Stantec Consulting Services Inc.
65 Network Drive, 2nd Floor, Burlington, MA 01803

March 3, 2021
File: MassDOT Project No. 606635 / 109597

**Reference: Request for Amendment to Order of Conditions (MassDEP File No. 239-815)
Reconstruction of Needham Street and Winchester Street, Newton Massachusetts**

FIGURE 7

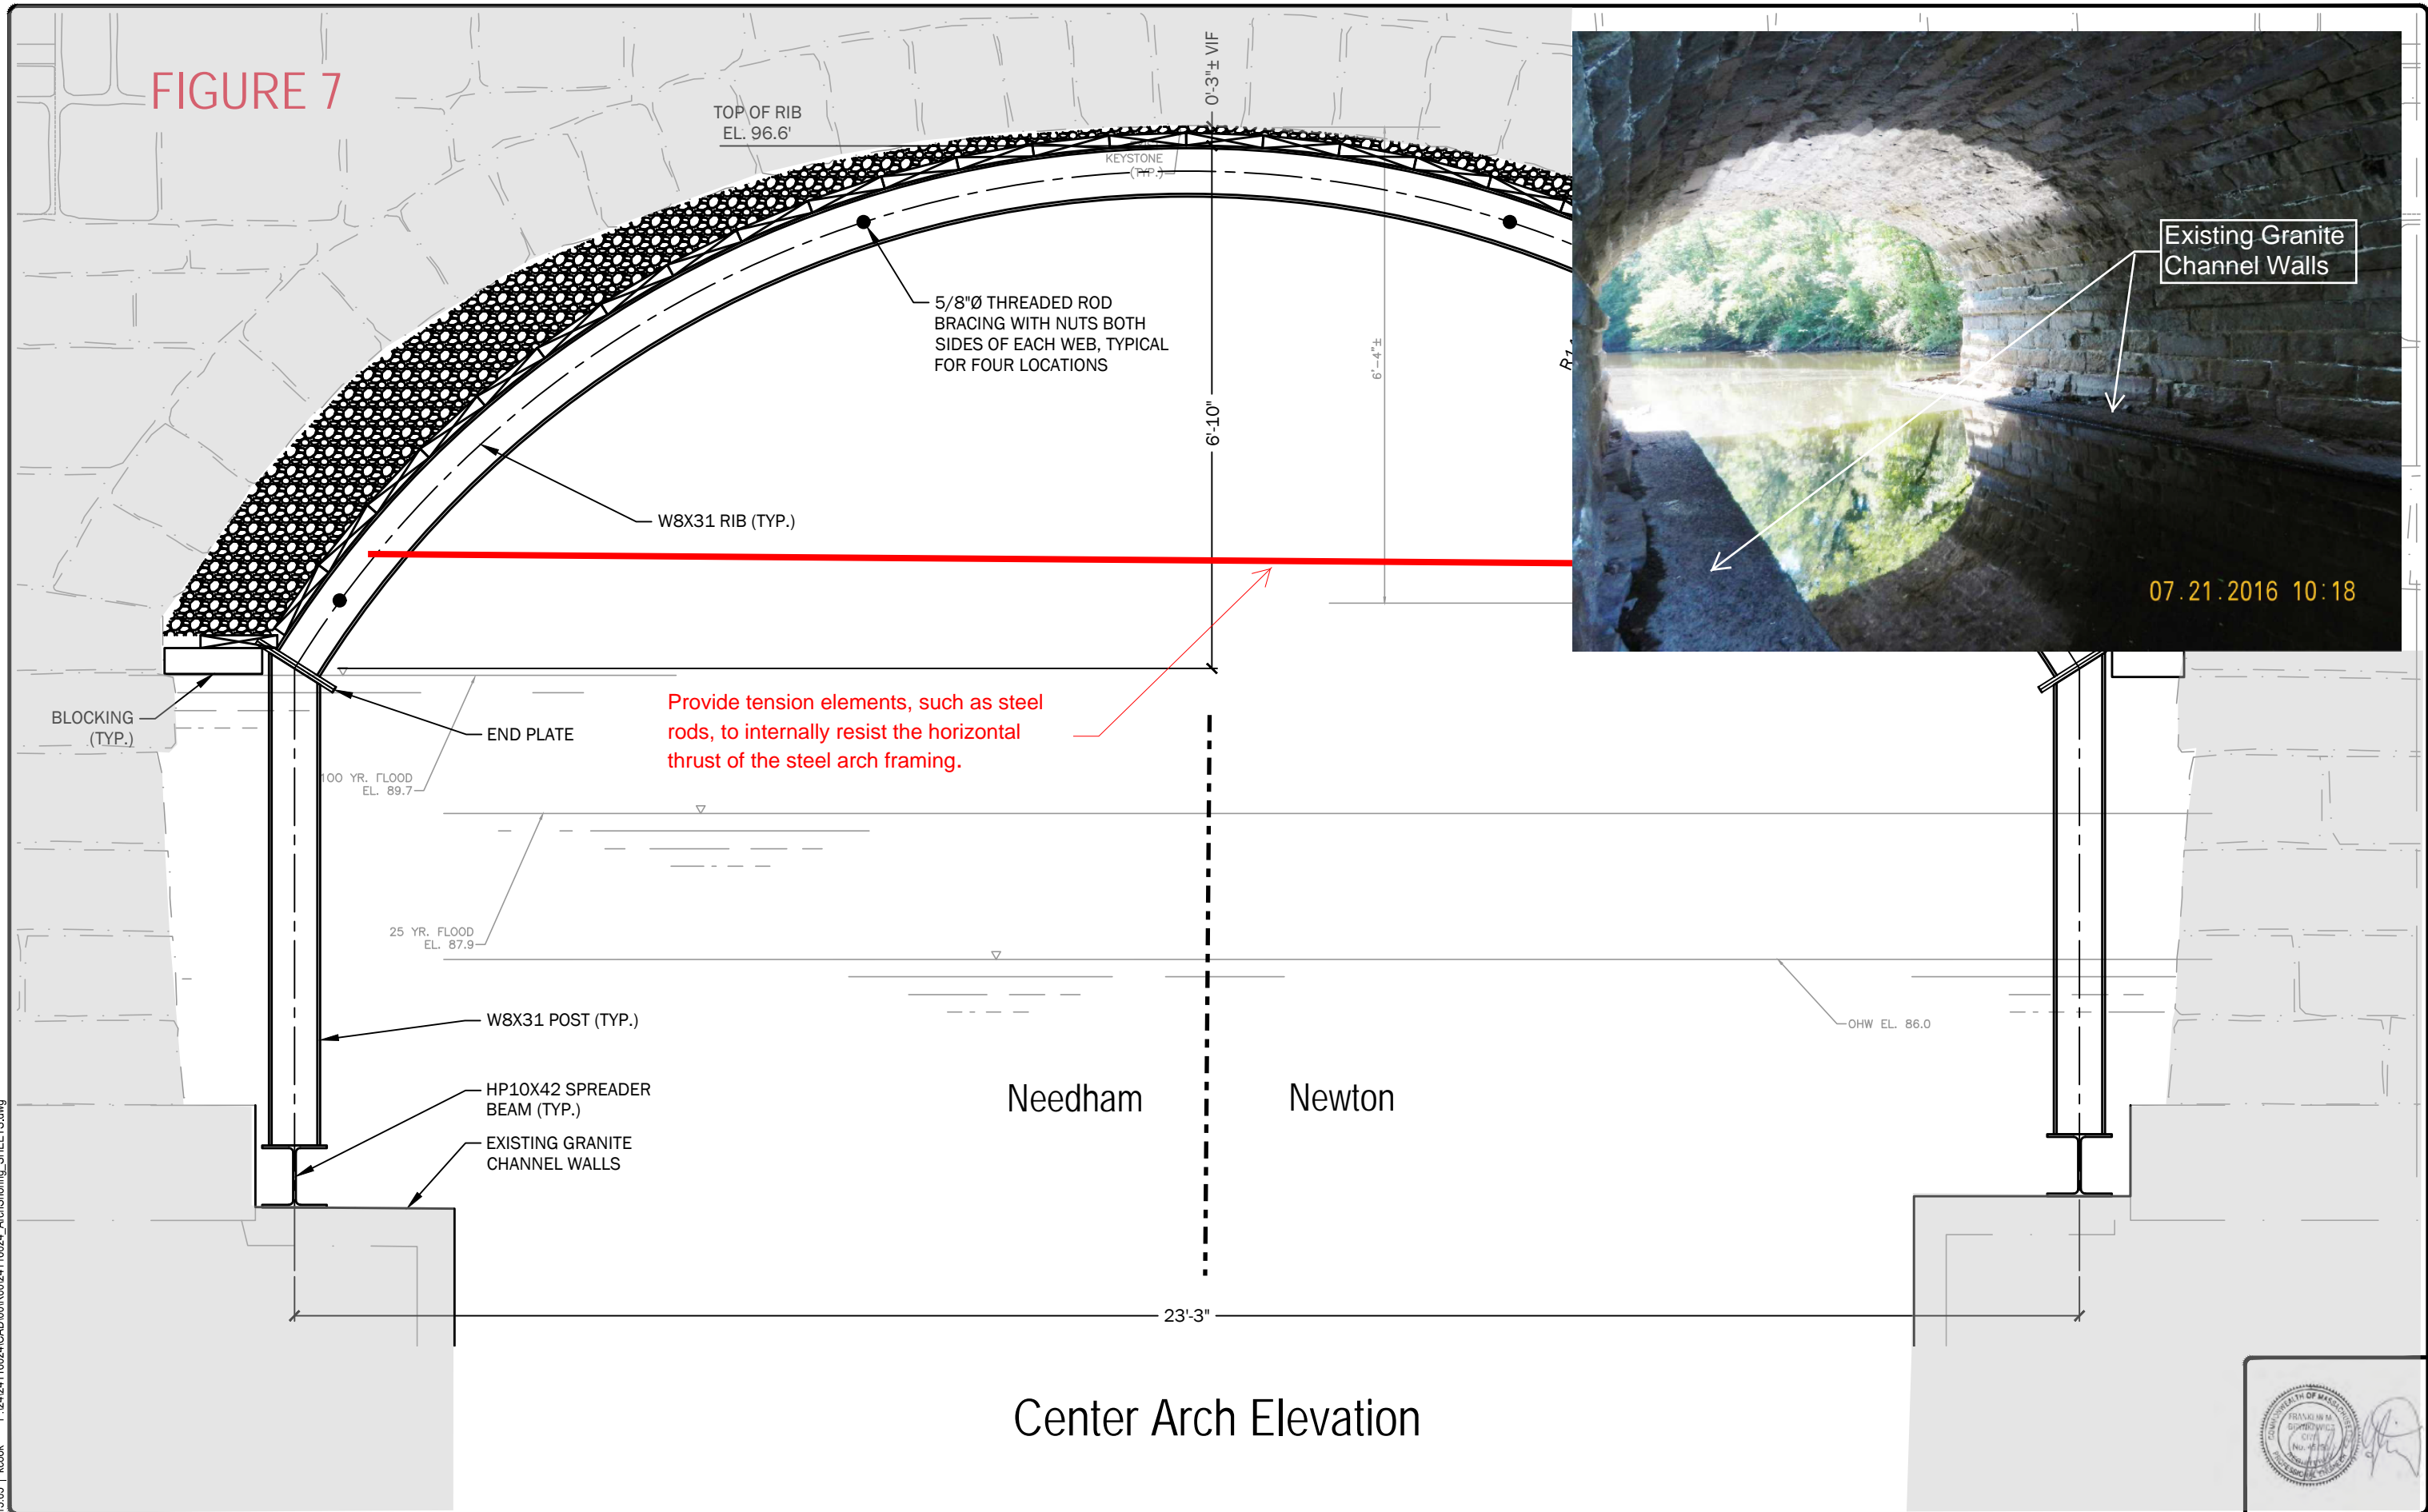
Construction staging within the river is necessary to support this effort. For the northern span, a 3,000 SF area will need to be established in LUWW to install a temporary support shield. Existing rocks and debris will be removed from under the arch and the area dewatered to place concrete footings to support the construction. Sandbags will be set up at the perimeter of the dewatering area and used for dewatering control. See Figures 6-9.

Provide tension elements, such as steel rods, to internally resist the horizontal thrust of the steel arch framing.

FIGURE 8 - CONSTRUCTION STAGING FOR TEMP SUPPORTS AND ARCH RE-POINTING - NORTH SPAN

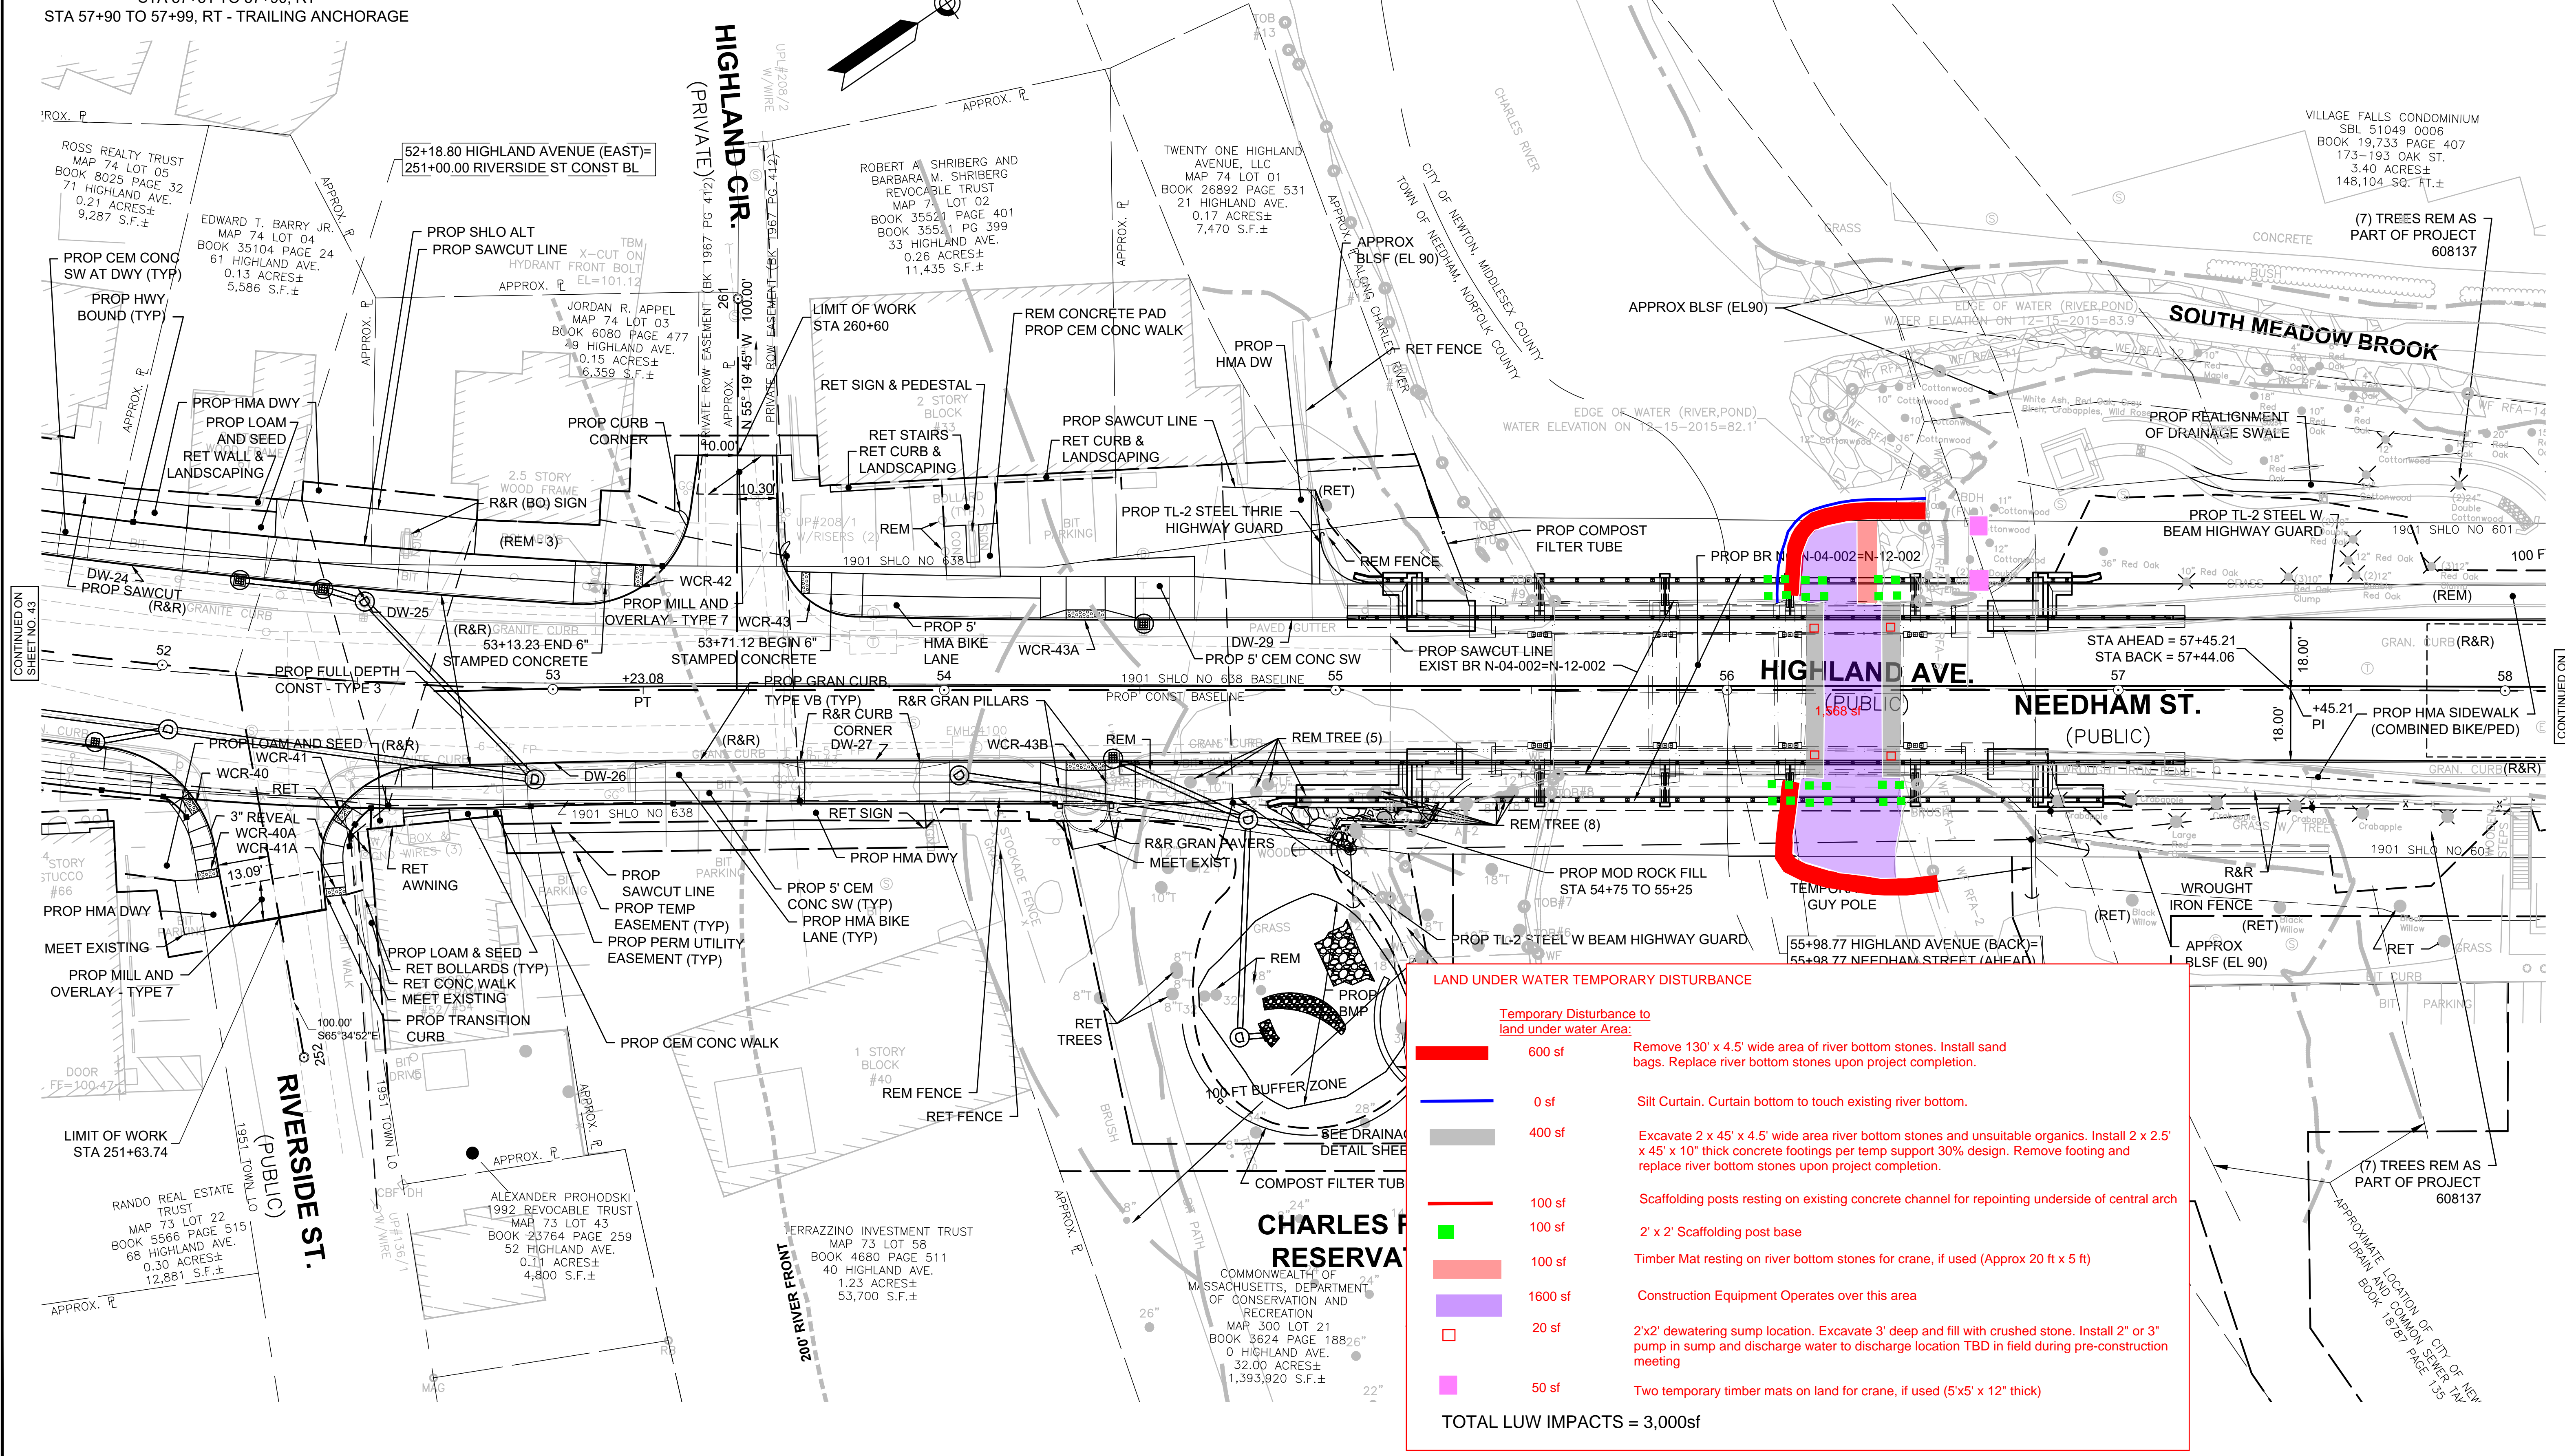
A turbidity curtain will be used on the downstream side of the northern arch. For the center span, a concept design being considered for the temporary support in the center span uses floating wooden rafts (8'x15') and a power boat for installation and demolition of the temporary supports. It is likely the navigable way will be closed to users during the installation and demolition. This work is to take place in BLSF and LUWW. See Figures 8 and 10.

Area	Disturbance to land under water Area:	Description
600 sf	Remove 130' x 4.5' wide area of river bottom stones. Install sand bags. Replace river bottom stones upon project completion.	
0 sf	Silt Curtain. Curtain bottom to touch existing river bottom.	
400 sf	Excavate 2 x 45' x 4.5' wide area river bottom stones and unsuitable organics. Install 2 x 2.5' x 45' x 10" thick concrete footings per temp support 30% design. Remove footing and replace river bottom stones upon project completion.	
100 sf	Scaffolding posts resting on existing concrete channel for repointing underside of central arch	
100 sf	2' x 2' Scaffolding post base	
100 sf	Timber Mat resting on river bottom stones for crane, if used (Approx 20 ft x 5 ft)	
1600 sf	Construction Equipment Operates over this area	
20 sf	2'x2' dewatering sump location. Excavate 3' deep and fill with crushed stone. Install 2" or 3" pump in sump and discharge water to discharge location TBD in field during pre-construction meeting

TOTAL LUW IMPACTS = 3,000sf
